Docket Number:	15-AFC-01
Project Title:	Puente Power Project
TN #:	213667
Document Title:	California Coastal Commission 30413(d) Report -- Final Approved Report
Description:	N/A
Filer:	System
Organization:	California Coastal Commission
Submitter Role:	Public Agency
Submission Date:	9/15/2016 1:45:02 PM
Docketed Date:	9/15/2016

RE: Coastal Commission's 30413(d) Report for the Proposed NRG Energy Center Oxnard, LLC Puente Power Project – Application for Certification #15-AFC-01

**Coastal Commission Report
to
California Energy Commission
on
Application for Certification 15-AFC-01
– NRG Puente Power Project –**

**Reviewed pursuant to
Coastal Act Section 30413(d)**

Figure 1 (PSA Fig. 4-2.2, *Vegetation Communities*). Proposed location for P3 outlined in yellow. More than 75% of the site is dominated by wetland vegetation including woolly seablite, pickleweed, and slenderleaf iceplant whose wetland status is FACW, OBL, and FAC, respectively.

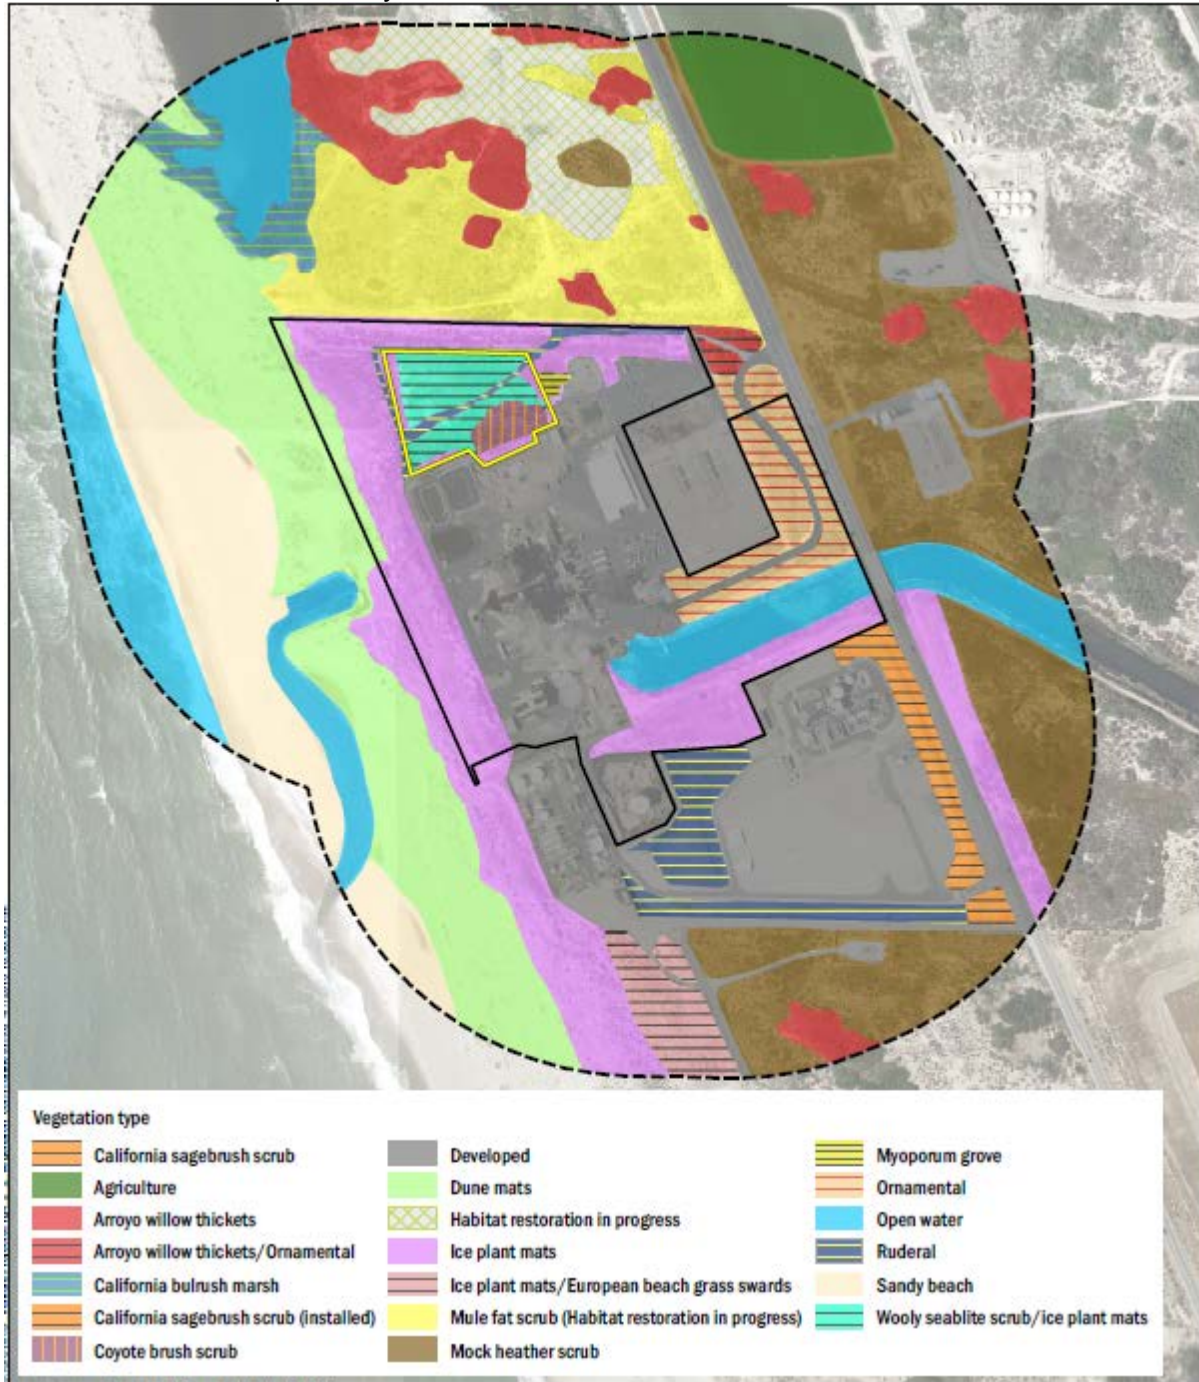
(*Mesembryanthemum nodiflorum*) (Figure 1). The National Wetland Inventory identifies the wetland status of these plants as FACW, OBL, and FAC, respectively. During the November site visit I carefully examined the vegetation in the area proposed for the power plant and confirmed that the area mapped as “woolly seablite scrub/ice plant mat” is dominated by the three species of wetland plants identified by AECOM.

Whether the soil salt content and compaction and presence of salt marsh species result from past activities or natural processes or a combination of both is not relevant because, for purposes of conformance with Coastal Act Section 30233(a), the Commission evaluates wetland indicators at a site in its present state. In this case, the area is dominated by three plants with wetland indicator status; one (pickleweed) with obligate (OBL) status meaning it is found in wetlands greater than 99% of the time, one (woolly seablite) with facultative wet (FACW) status meaning it is found in wetlands 67 to 99% of the time, and one with facultative (FAC) status meaning it is found in wetlands between 34 to 66% of the time. If the site supported just one or two FAC species, we would consider the possibility of a false positive wetland determination. However, this is not the case at the proposed power plant site.

Based on the Commission’s wetland definition, AECOM’s wetland delineation, and my site visit observations, I find that the area identified by AECOM as “woolly seablite/ice plant mat” within of the area proposed for Puente Power Plant is wetland habitat (approximately 75% of the site).

Exhibit 7
15-AFC-01
NRG Puente Power Project
Vegetation in Project Area
Page 1 of 1

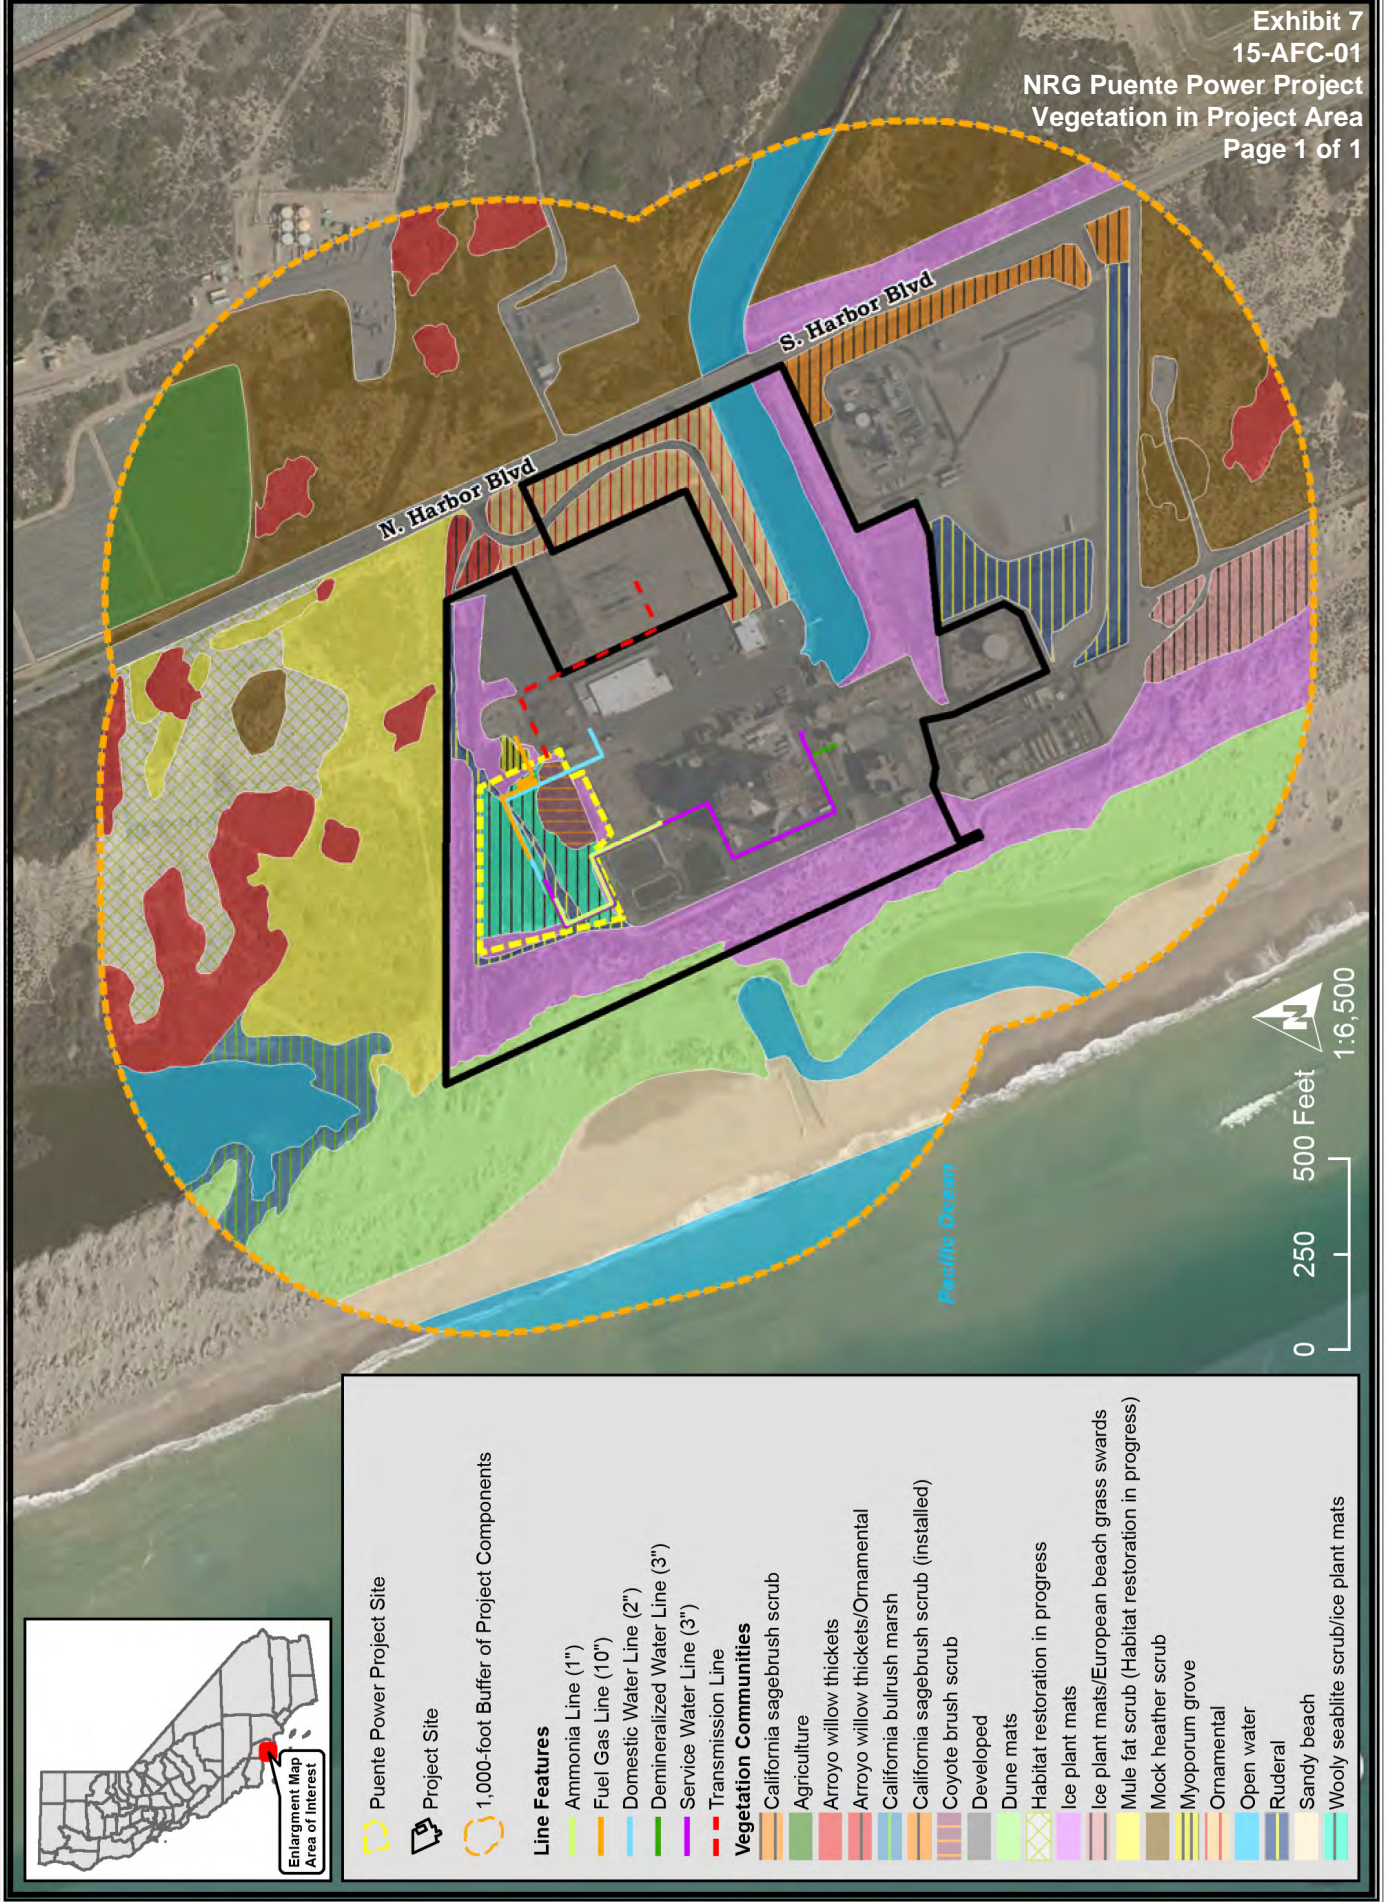
LCP Policy 6 requires a minimum 100-foot buffer between new development and resource protection areas, including ESHA and wetlands. As shown in the PSA and [Exhibit 7](#), the boundaries of the P3 project site are located approximately 100 feet from mulefat scrub ESHA (some of which is currently undergoing habitat restoration, see above), which could result in non-conformity to this LCP policy. The P3 site is also immediately adjacent to a line of coastal dunes that, though dominated by non-native iceplant vegetation, may nonetheless provide habitat value.

To ensure the project conforms to the extent feasible with LCP Policy 6, we recommend the Energy Commission modify **Condition BIO-7** to require that NRG design the P3 such that all project-related development is at least 100 feet, and further, if feasible, from nearby areas that meet the Coastal Commission and LCP definitions of wetlands or ESHA. We also recommend that submittal of revised project plans be required to reflect these changes in the project layout.

This recommended modification would also require NRG to submit a revised project plan showing that all project-related development is at least 100 feet from wetlands and ESHA. This requirement could be met through the selection of an off-site alternative location (such as the Ormond Beach Area site), relocating the project to one of the two on-site alternative locations identified in the Alternatives section (PSA pages 211-324), or by moving the proposed project footprint (specifically, the construction and laydown area) a few dozen feet away from the northern boundary of the site, which abuts the wetland/ESHA restoration area. Such an adjustment would appear to be feasible based on the amount of space available within the project site.
